SECTION 645 - TRAFFIC CONTROL DEVICES

STP-050-1(24)
645-7a

TWO-LANE HIGHWAY - ONE LANE CLOSED
FIGURE 1 - TRAFFIC CONTROL PLAN

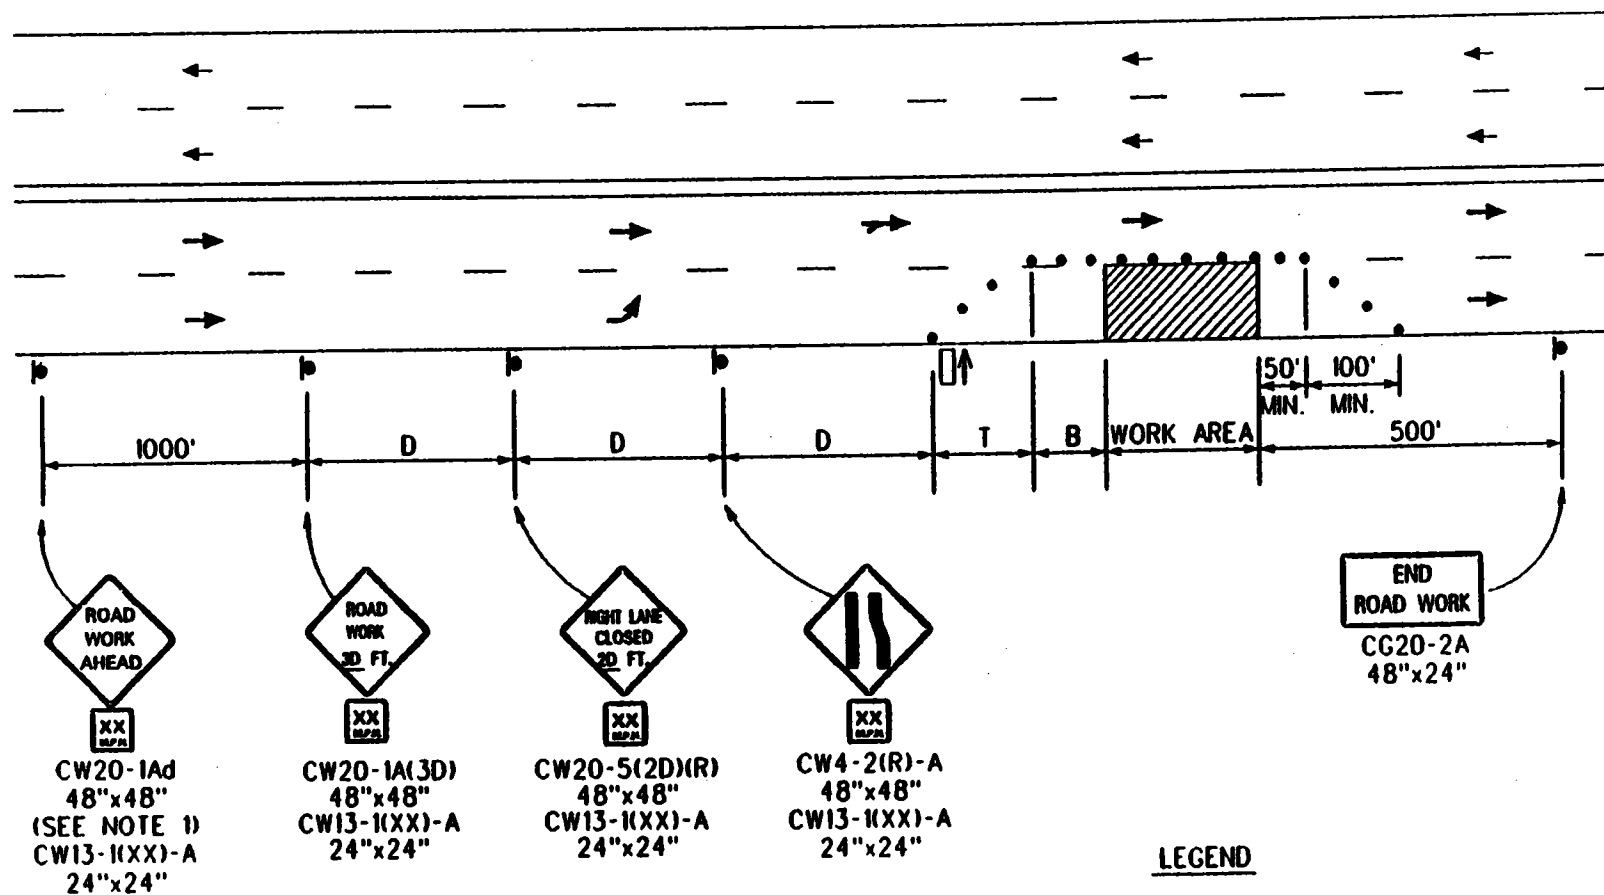
(VI) Replace Figures 1 through 6 dated 5/01/93 with the attached Figures 1 and 2 dated r2/97 and Figures 3 through 7 dated r10/96.
